Subject: Addendum to the Minor Amendment Approval Letter for Partners on Fourth PAD-33 dated July 9, 2019.

Subject: Minor Amendment Request for Partners on Fourth PAD-33

Re: C9-18-01 Minor Amendment Requests
For the Approved Multi-Use Project – COI Pad 33-
Partners on Fourth – 4th Avenue and 8th Street

EXHIBIT 9: PAD CONCEPT PLAN

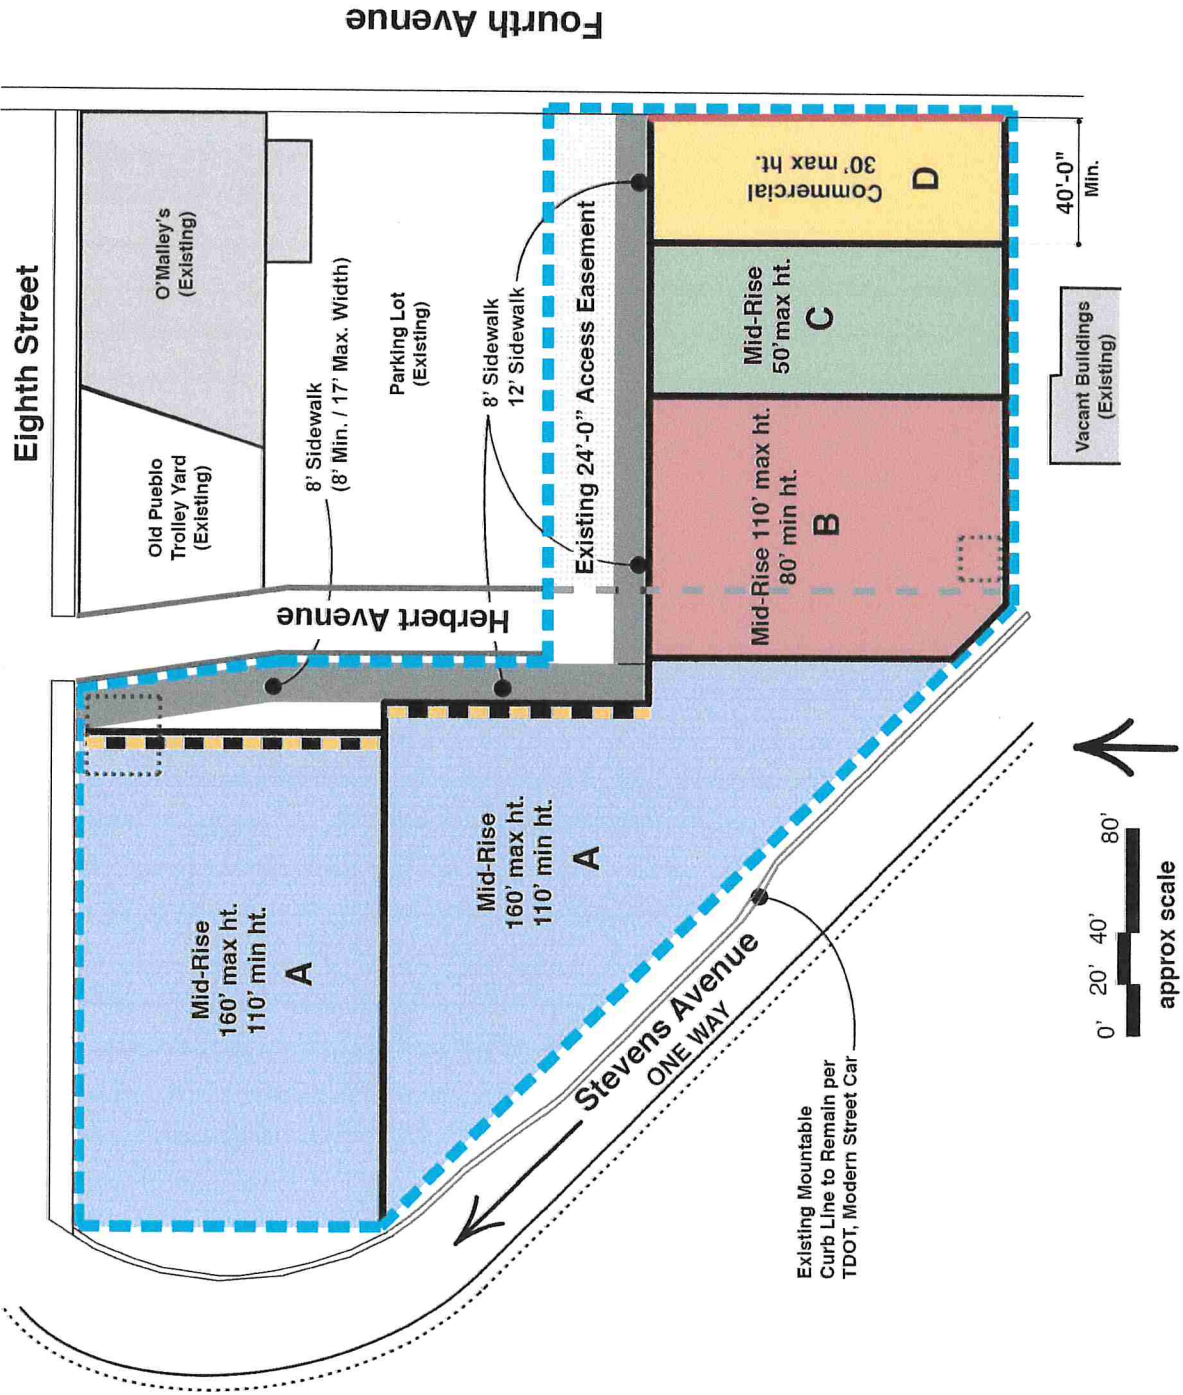
Item 1 *Sidewalk Widths:* You have requested a minor amendment to decrease the sidewalk widths as presented in Exhibit 9: PAD Concept Plan. You propose sidewalk widths that vary from 8-foot minimum to 17-foot maximum along Herbert Avenue (north-south sidewalk), and sidewalk widths that vary from 8-foot minimum to 12-foot maximum along the east-west access easement. The intent of this request is to address the view of and within the development along the east-west access easement as well as to create a more inviting pedestrian space within the site. The PAD currently indicates on Exhibit 9: PAD Concept Plan, a minimum of 15-foot wide sidewalk along Herbert (north-south) and a 12-foot wide sidewalk along the Access Easement (east-west).

(22.) 2-06.4.9.R - Show on-site pedestrian circulation and refuge utilizing location and the design criteria in Section 7-01.0.0, Pedestrian Access, of the Technical Standards Manual. Pedestrian sidewalks along the access easement are shown at 7.33' in width. The PAD indicates on Exhibit 9: PAD Concept Plan a minimum 12' sidewalk in this easement area.

(24.)2-06.4.9.S - Show existing or proposed pedestrian circulation along abutting rights-of-way. Pedestrian sidewalks along Herbert Ave are shown at 6' and 4'. The PAD indicates on Exhibit 9: PAD Concept Plan a minimum 15' sidewalk along Herbert. Pedestrian sidewalks along Stevens Ave are shown varying in width down to 2.94'. Per PAD Part III.3.E(1) a minimum 6' sidewalk is required.

Condition: Revise the PAD document on page 18 (PAD-33 Part III.1. Exhibit 9: PAD Concept Plan) to show varying sidewalk widths. Change the following sidewalk notations on the exhibit:

- Sidewalk along Herbert Avenue (north-south):
Varies 8-foot min to 17-foot max
- Sidewalk along east-west Access Easement:
Varies 8-foot min to 12-foot max

The East-West pedestrian sidewalk as shown on the attached revised Exhibit 9 and 10 PAD Concept Plan and the detailed "Pedestrian – Vehicle Circulation Plan" will vary between 12'-8' clearance on sidewalk width. In our stakeholder meetings it was requested that there be shade trees and landscaping along the walkway. The intent of this request is to address both the user and the view from 4th Avenue locations, in order to soften the view of the development.

The North-South Pedestrian sidewalk as shown on the attached revised Exhibit 9 and 10 PAD Concept Plan and the detailed "Pedestrian-Vehicle Circulation Plan" will vary between 8'-17'. The variance is a result of enhancing the entry way to the building to the project lobby and enhancing north - south sidewalk with landscaping along Herbert from the building entry way north to 8th Street. In addition, a convenient bicycle parking area is provided, in order to meet bicycle parking requirements. The bicycle parking is provided on the wider sidewalk area. The walkway clearance between the bicycles will not be less than 8ft.

EXHIBIT 10: PAD NEW CONCEPT CIRCULATION PLAN

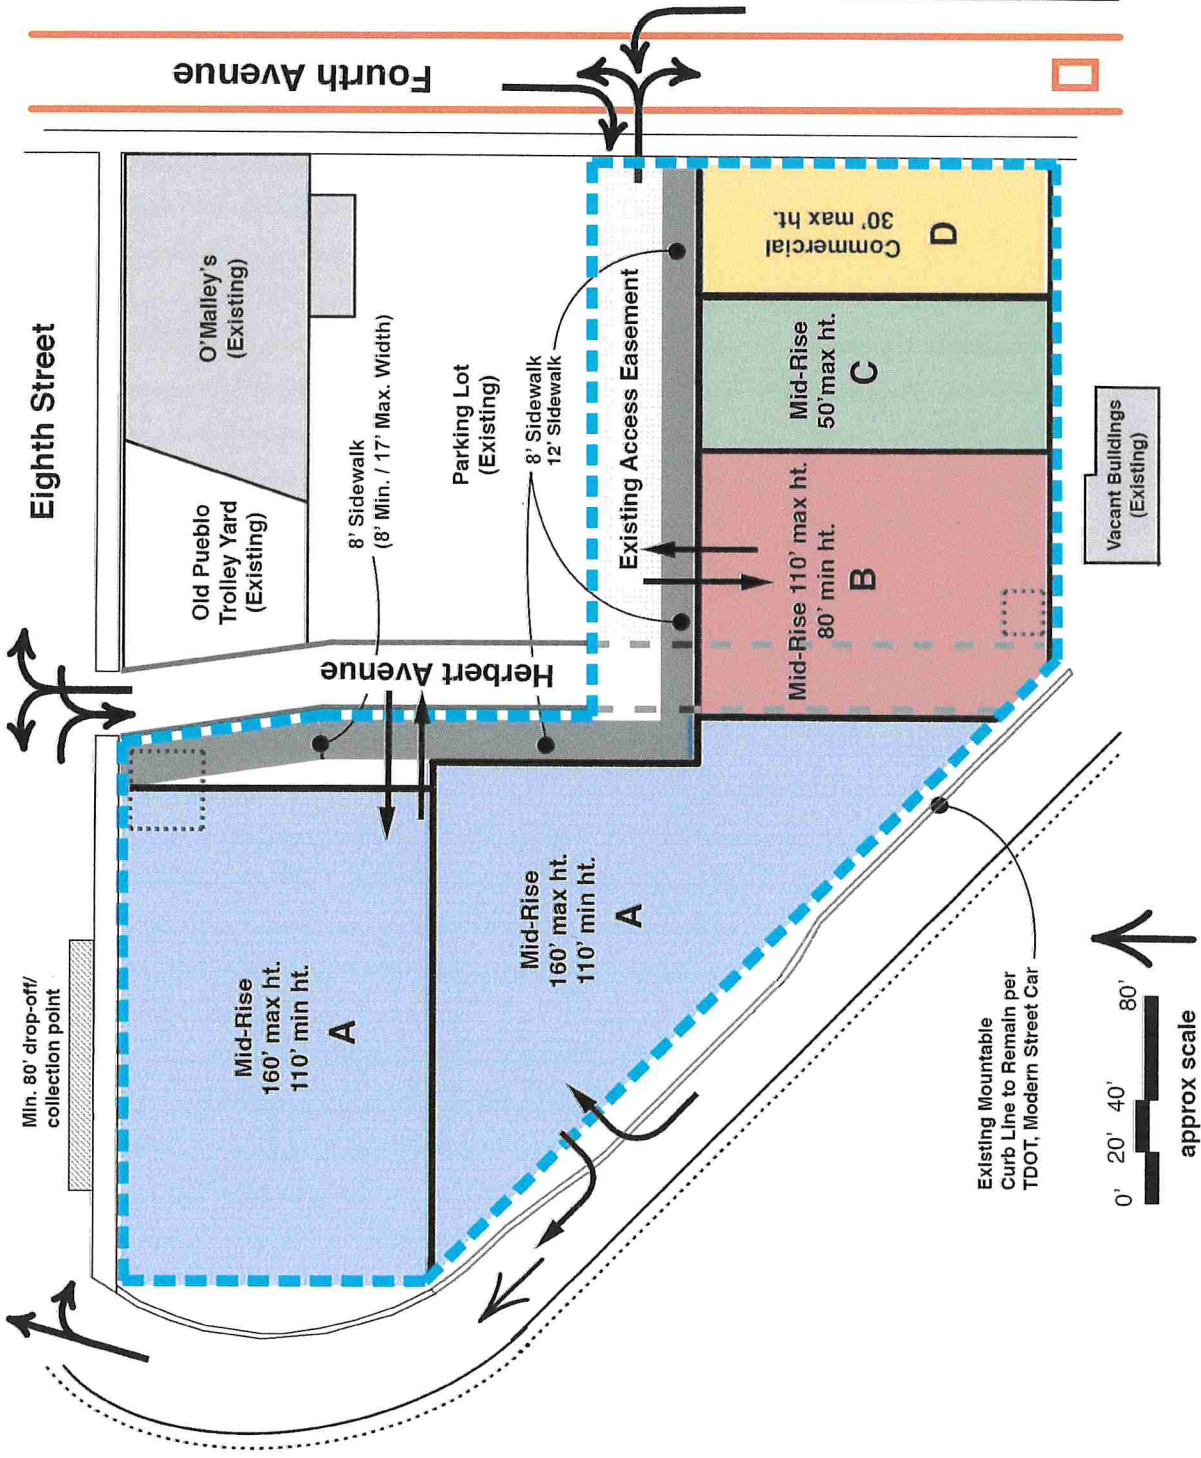
Item 3 Circulation Plan: In your request letter you have asked for a minor amendment to change the access points indicated in Exhibit 10: PAD New Concept Circulation Plan. In order to meet the adequate parking requirements and the appropriate life safety curb cuts on the corner of Stevens and 8th Street the request is to move access from the entrance off of 8th street, to an entrance into Section A parking garage off of Herbert Avenue and an entrance into Section B parking garage off of the east-west access easement.

(30.) Per PAD Part III.3.D(6) parking access is specifically outlined per Exhibit 10 and further mentioned in Part III.4.B. Vehicular access is not illustrated or listed along Herbert Ave or through the access easement. The submitted plan does not comply with the PAD and illustrates garage entrances on Herbert Ave and along the access easement. Additionally, PAD Part III.4.C. states points of ingress and egress shall be minimized wherever possible.

- On page 33 (PAD-33 Part III.4.B. Vehicular Access)
 - Remove
 - Ingress from Eighth Street into a surface level parking lot below the building
 - Egress from surface level parking lot below the building onto Eighth Street

- Add
 - Ingress from Herbert Avenue into Section A Parking Garage
 - Egress from Section A Parking Garage onto Herbert Avenue
 - Ingress from PAD Easement into Section B Garage
 - Egress from Section B Garage onto PAD Easement
- On page 34 (PAD-33 Part III.4.C. Exhibit 10: PAD New Concept Circulation Plan) to show proposed access changes

On the original design of Exhibit 10 the egress and ingress into the parking garage is very close to Stevens Avenue entering 8th Street and also allowed for a maximum of 4 drop-off vehicles. As shown on the revised attached Exhibit 10 PAD Concept Circulation Plan and the attached Pedestrian-Vehicle Circulation plan the capacity of 6 drop-off transportation can be achieved and the ingress egress of the garage located on Herbert will alleviate the additional ingress and egress on 8th Street within such a confined area. Also, again limited by the boundaries a loss of parking spaces would occur due to the lack of proper parking geometry.

A Minor Amendment is requested to allow the PAD to include the revised Exhibit 10 PAD New Concept Circulation Plan and the attached Pedestrian-Vehicle Circulation Plan in order to meet the adequate parking requirements and the appropriate life safety curb cuts on the corner of Stevens and 8th Street.
